SUNNINGDALE PARISH COUNCIL

Land At Hill House Cross Road Sunningdale Ascot

Reference: Planning Application 21/03405/VAR; Variation (under Section 73) of conditions 17 (flank windows to be obscure glazed) and 18 (approved plans) to re-word condition 17 and to substitute those plans approved under 16/02220/FULL for construction of 5 No. apartments with basement and new access.

The rear elevation of the apartments proposed under 15/01199 is shown to the right

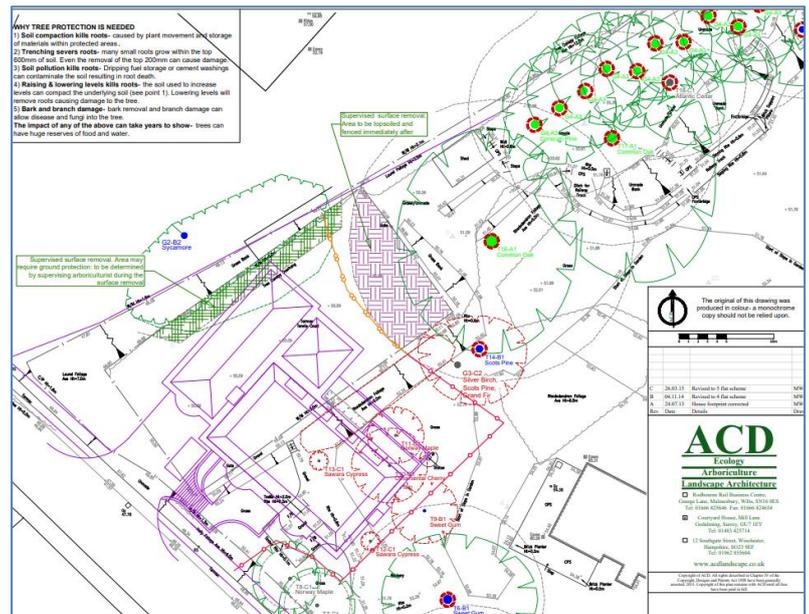
15/01199 for 4 x 2 bed and 1 x 3 bed apartments was rejected at Appeal. The Inspector's main reason for rejecting the application was the effect of this multiple occupancy dwelling on the longevity of a mature, protected and ancient oak tree in the rear garden. The Inspector's comments were clearly applicable to multiple occupancy dwellings on this site: *'the outlook from the rear windows on each of the units above ground level would be dominated by the tree. 'The tree may come to be considered as a nuisance rather than an asset to future occupiers by reason of its size and dominance'.*

21/03405 Proposed scheme - rear elevation

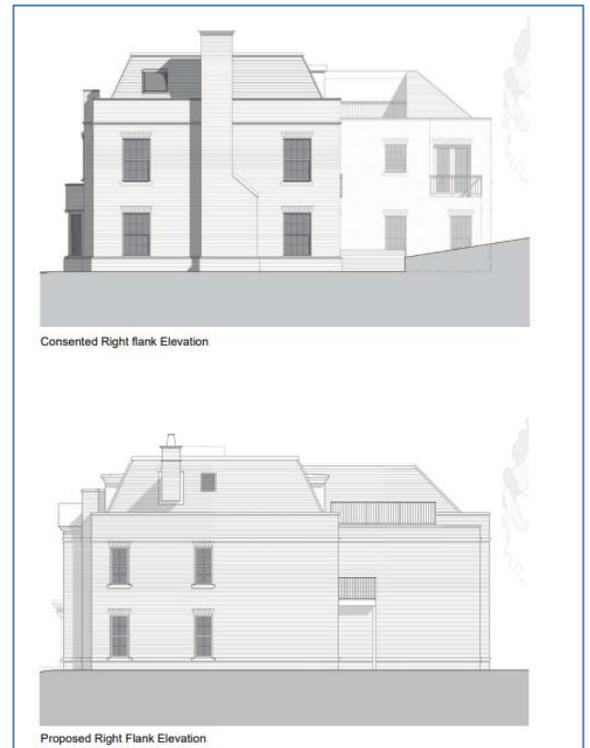
As can be seen in the proposed rear elevation below under 21/03405 the developer has now **added three new windows** on this Northwest corner. This directly contradicts the recommendations of the Inspector.

The number of windows at the rear of the building now exceeds any of the previous applications.

There is also a significant increase in bulk on the rear elevation as a result of the infilling of the roof. The dormer windows have been increased in width, an additional window added in the roof and (as mentioned above) three new windows added to the section of the building that was previously 'annexed' from the main building but now has been absorbed into the overall mass.
